ADDENDUM No. TWO

Project Name: Holts Landing Boardwalk & Trail Improvements
 Holts Landing State Park

Project No.: HL-10C

Date of Issue: February 20, 2019

STRUCTURAL DETAILS

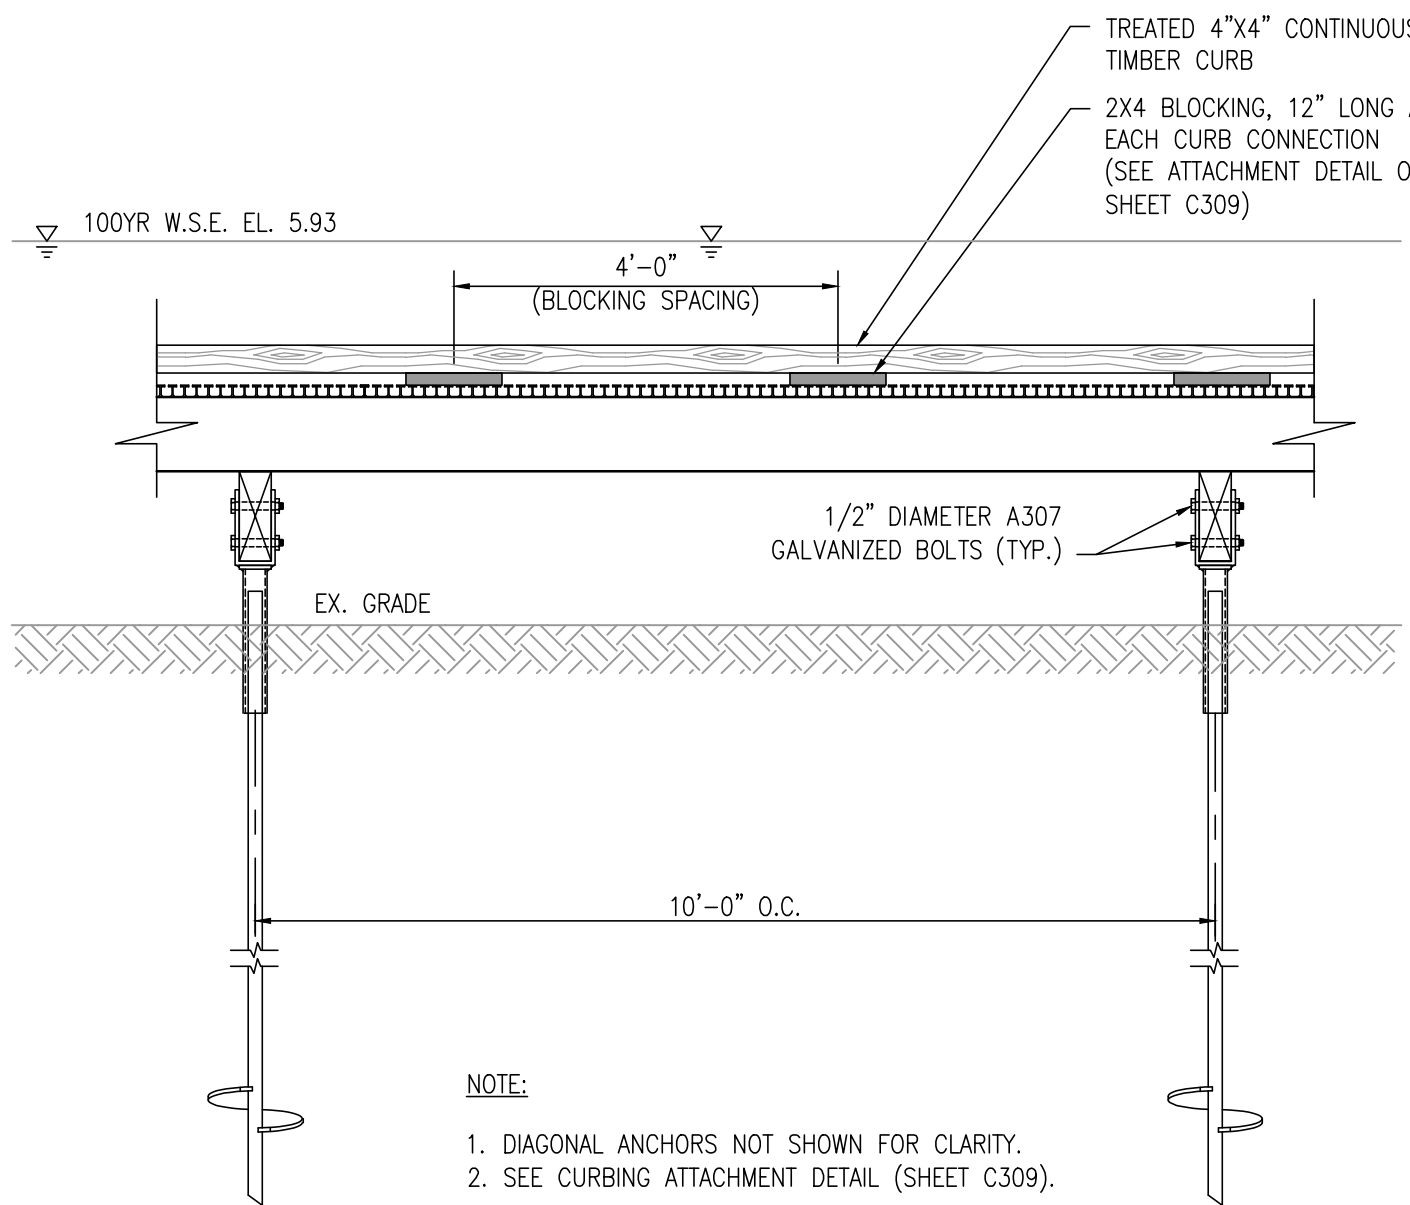
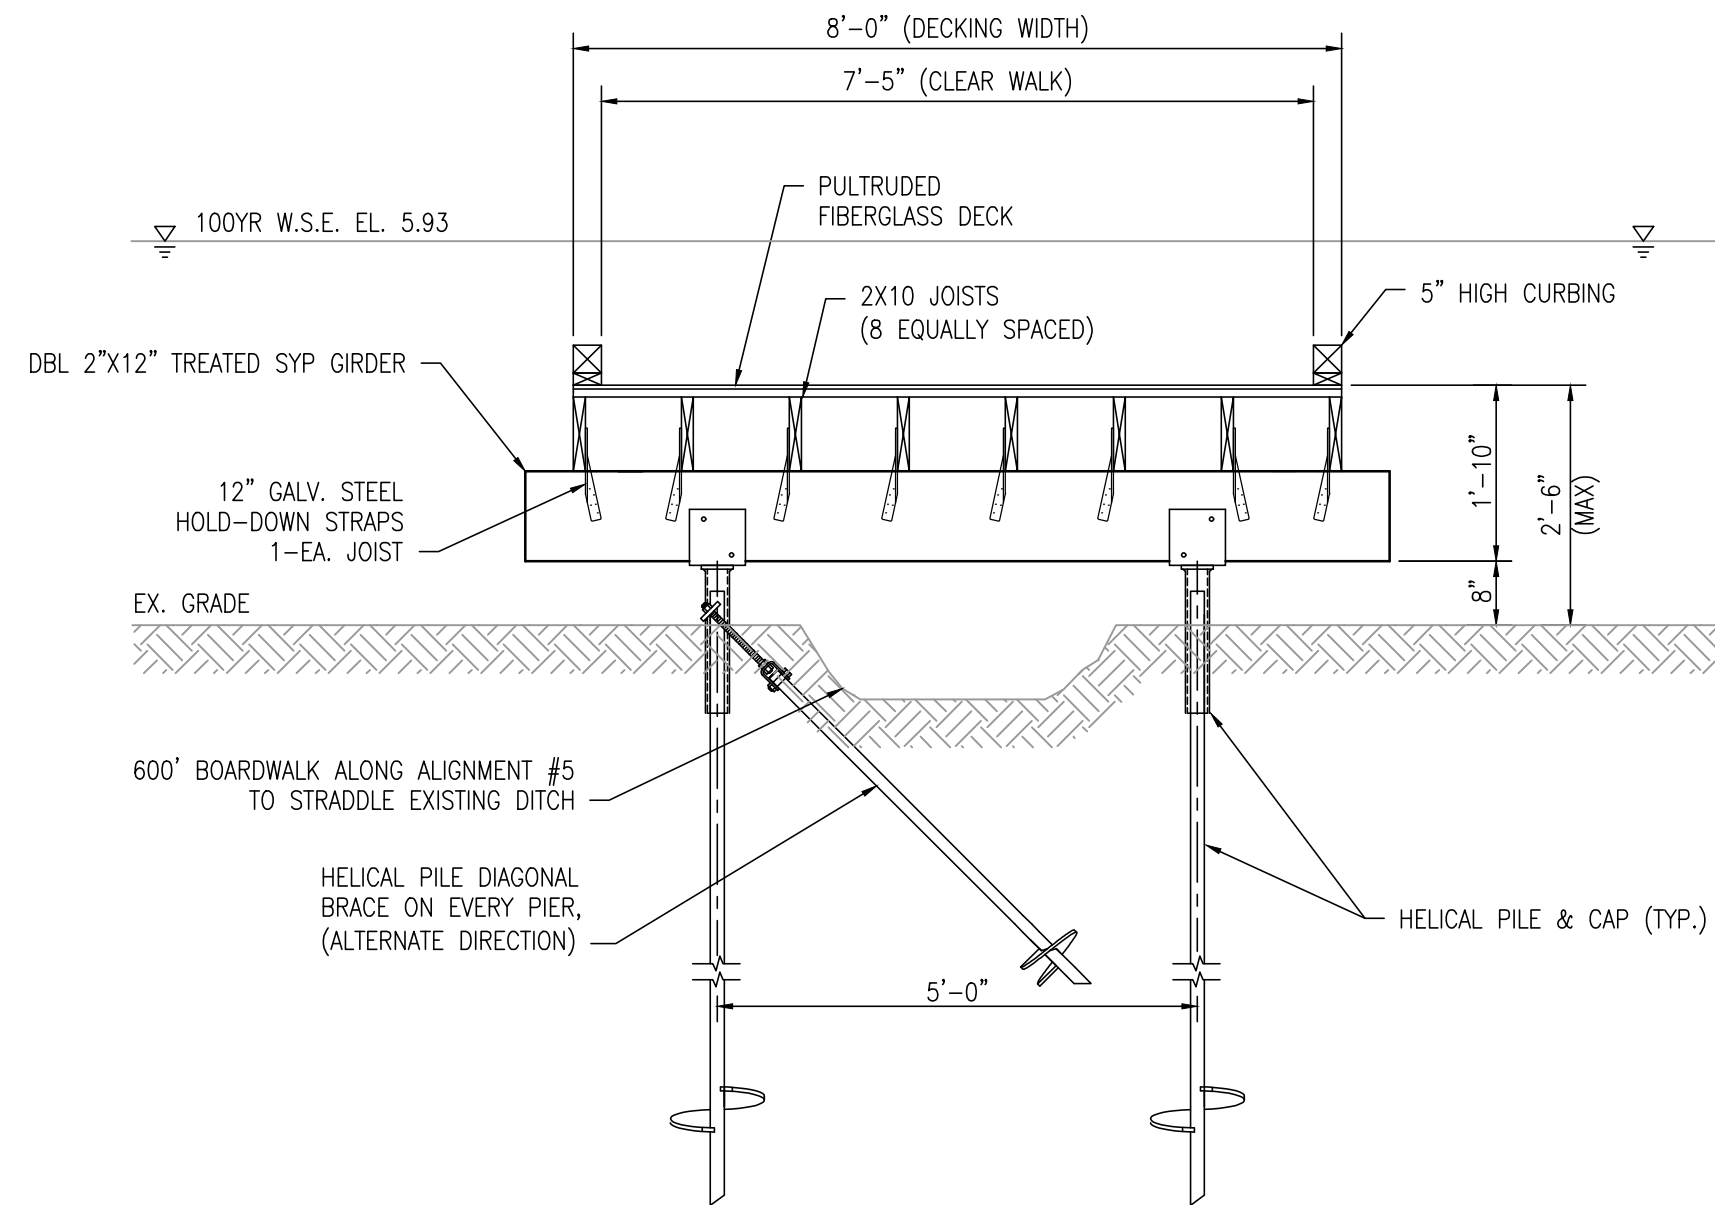
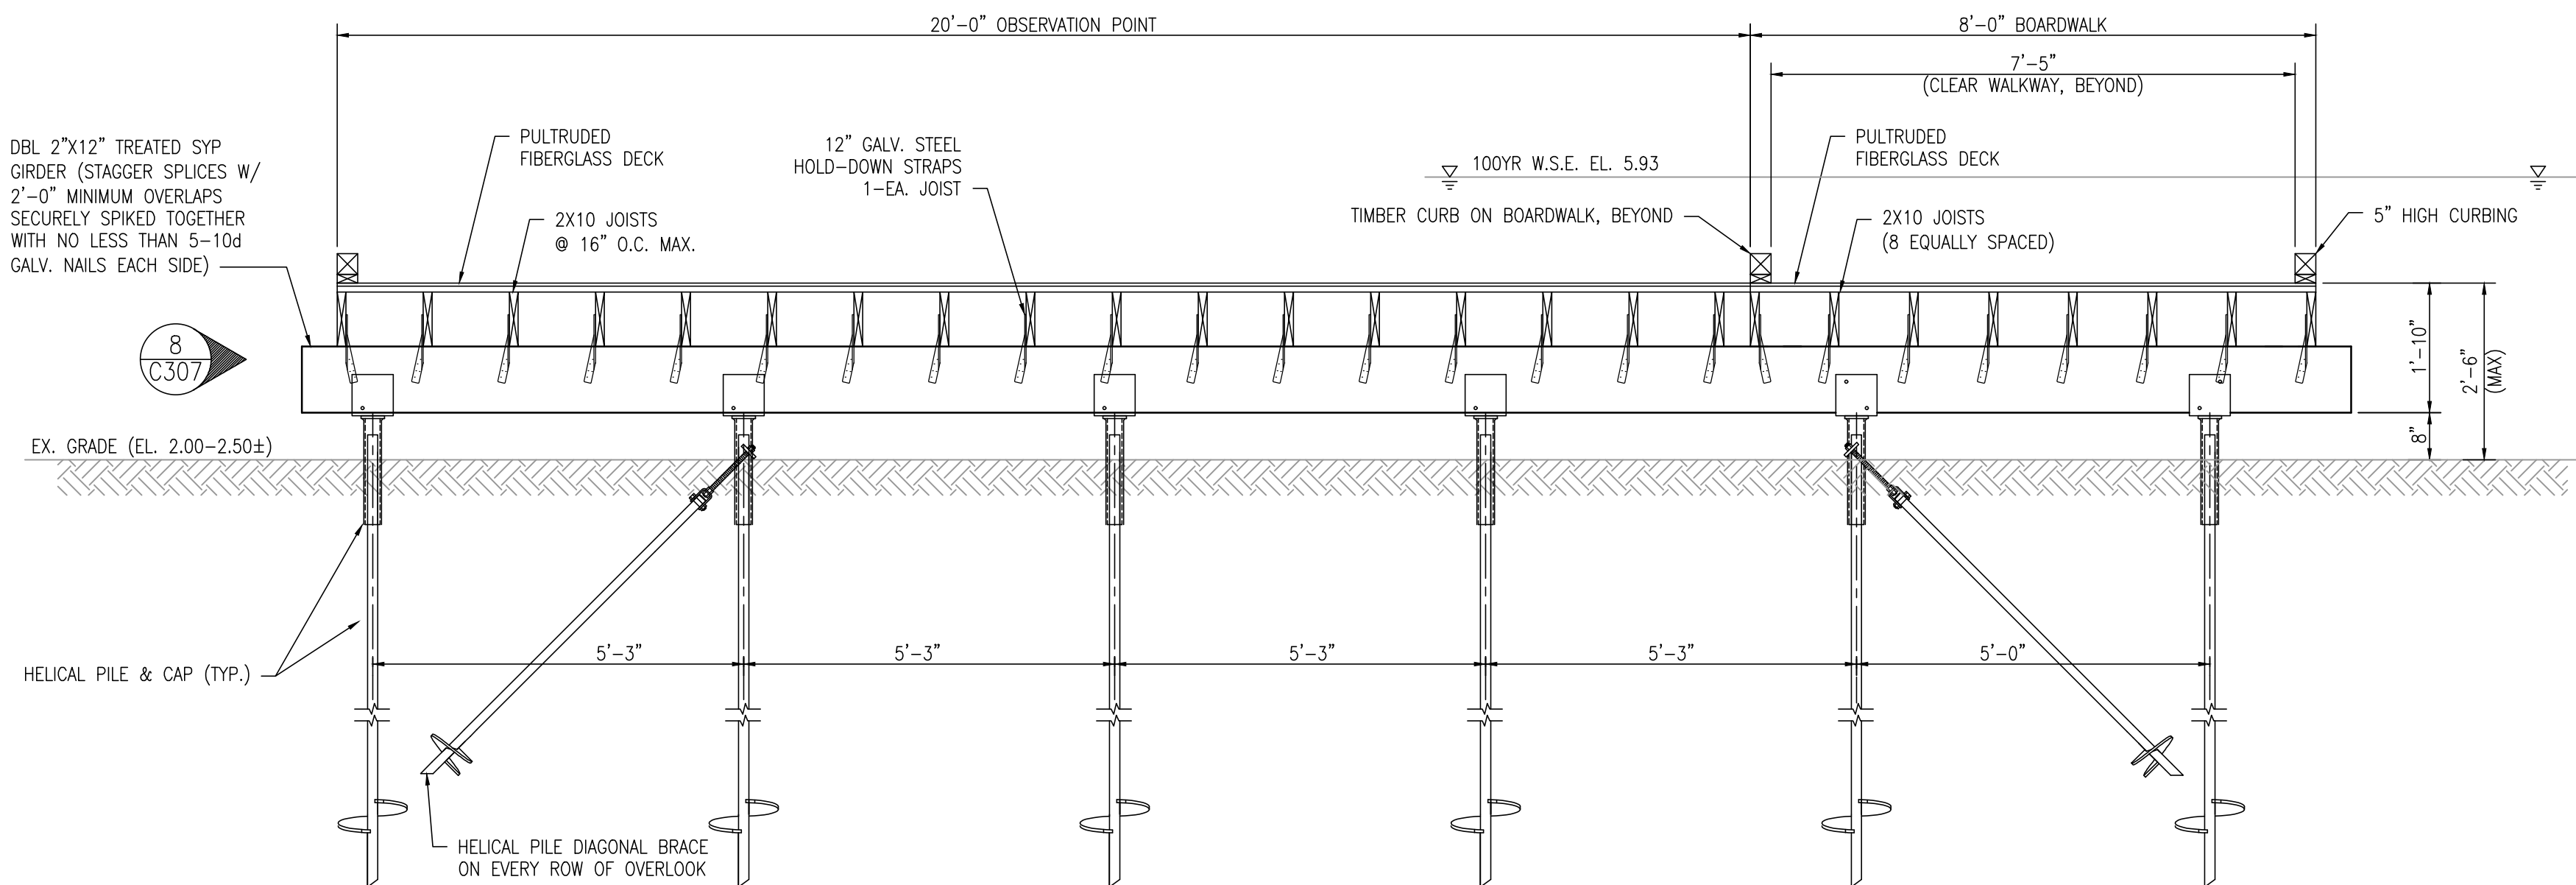
1. Plan Sheet C301: Added Project Notes and Legend
2. Plan Sheet C308: Note revision to the Pultruded Fiberglass Decking

14. Drawing C308 states to use grey or brown grating. Will grey be acceptable? There is an upcharge for brown.

A: Strike "brown" from the plans and specifications. All pultruded decking shall be grey in color.

DATE: 2/12/2019
DESCRIPTION: REVISED PULTRUDED DECKING REQUIREMENTS

4
C308
SECTION AT OBSERVATION POINT
SCALE: 1" = 1'-0"

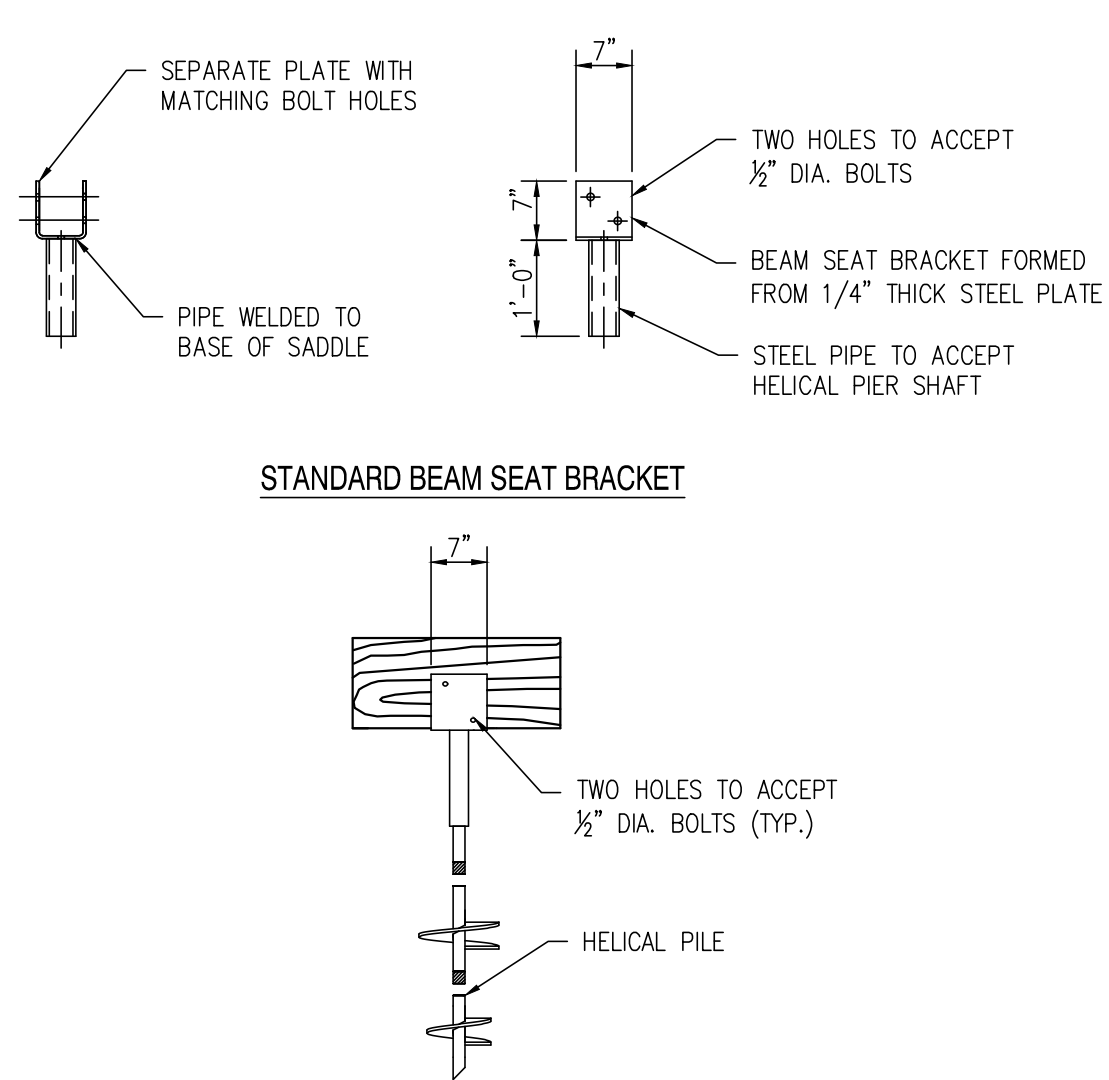
13. Drawing C305 references 7 on C307, there is no detail 7 on C307. Please advise.

A: Refer to Detail 4 on Sheet C308.
